**Amendments to the Drawings:**

## REMARKS

### Drawings

Fig. 4E

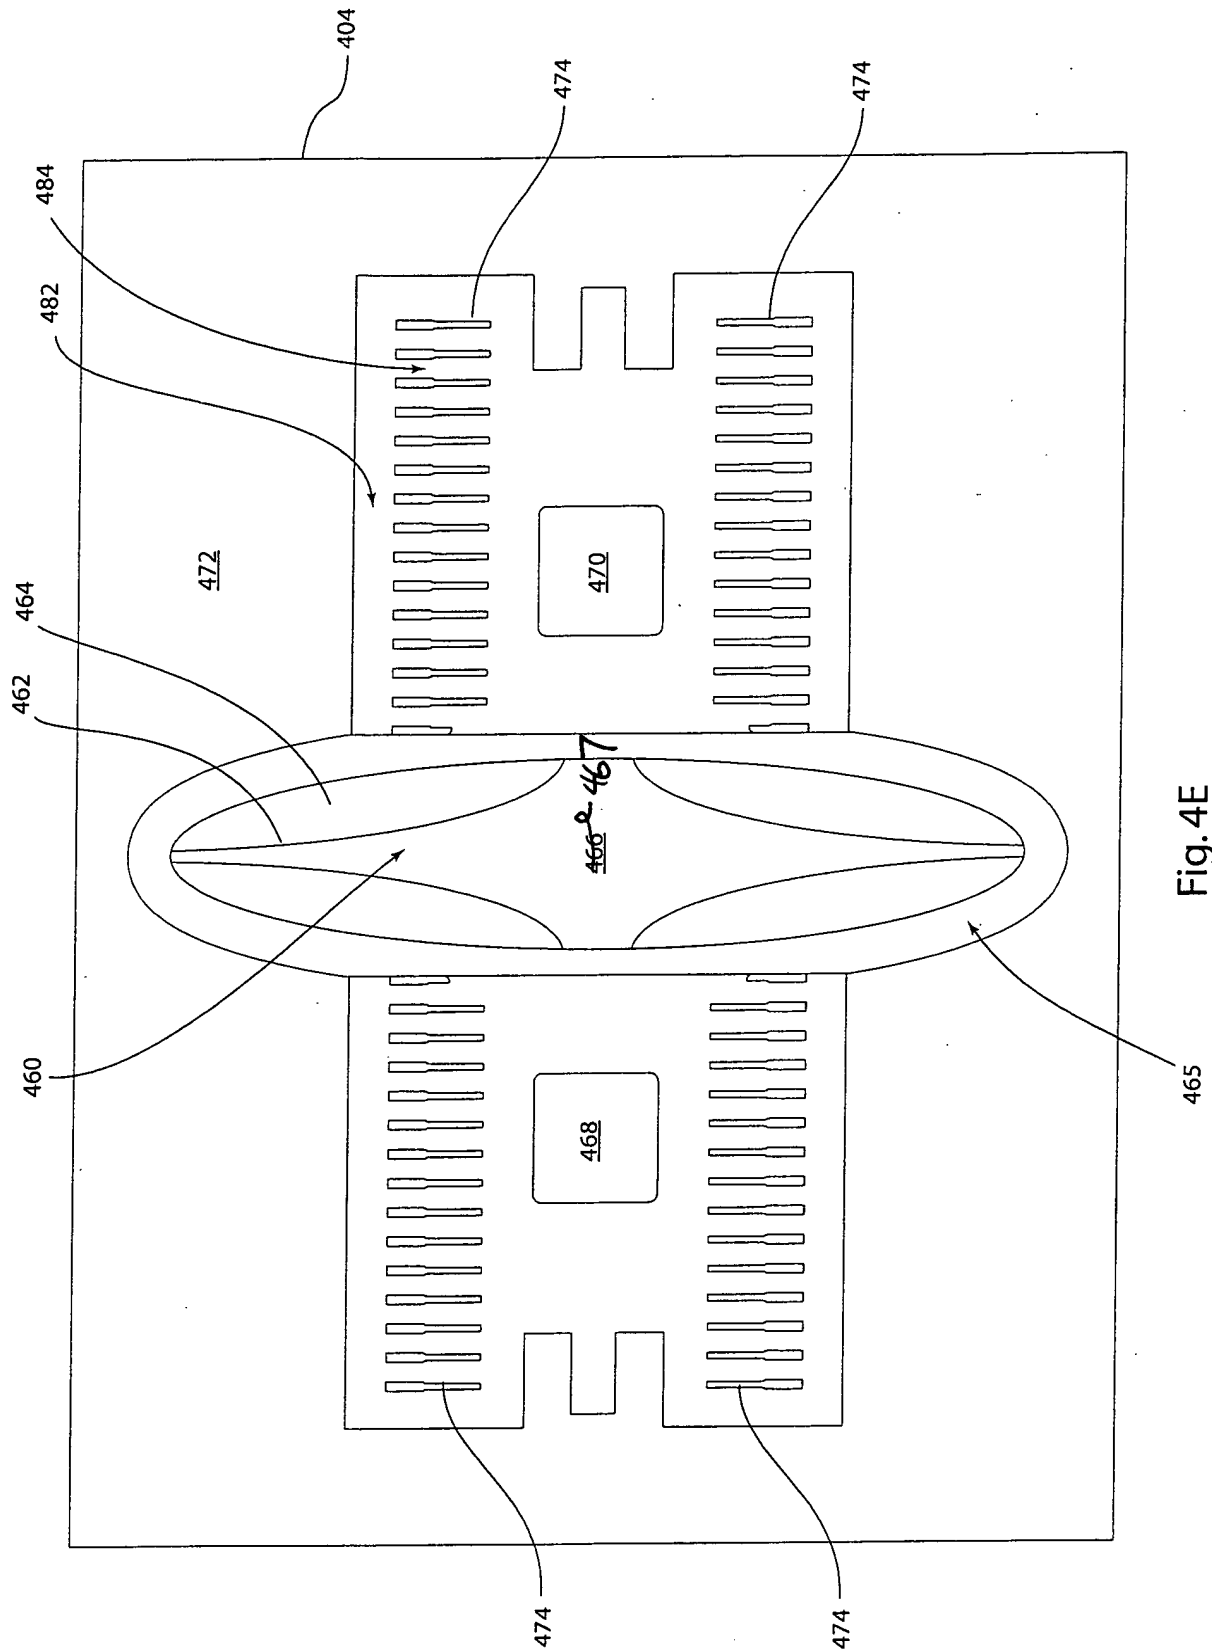
The attached sheets of drawings include changes to Figs. 4E, 4F, and 4G, 6C, 6F, and a new Fig. 6F-1. In Fig. 4E, Applicant has corrected a reference number 466 to 467. In Fig. 4F, Applicant has added a reference number 404. In Fig. 4G, Applicant has corrected a duplicative reference number 464 to 462, and added additional reference numbers 416, 434, and 474. In Fig. 6C, Applicant has added a reference number 633. Applicant has added Fig. 6F-1 in response to an objection by the Examiner.

In Fig. 4E, Applicant has corrected a reference number 466 to 467. In Fig. 4F, Applicant has added a reference number 404. In Fig. 4G, Applicant has corrected a duplicative reference number 464 to 462, and added additional reference numbers 416, 434, and 474. Again, this is done to show the rotational and stationary comb teeth are interdigitated in-plane and out-of-plane. In Fig. 6C, Applicant has added a reference number 633.
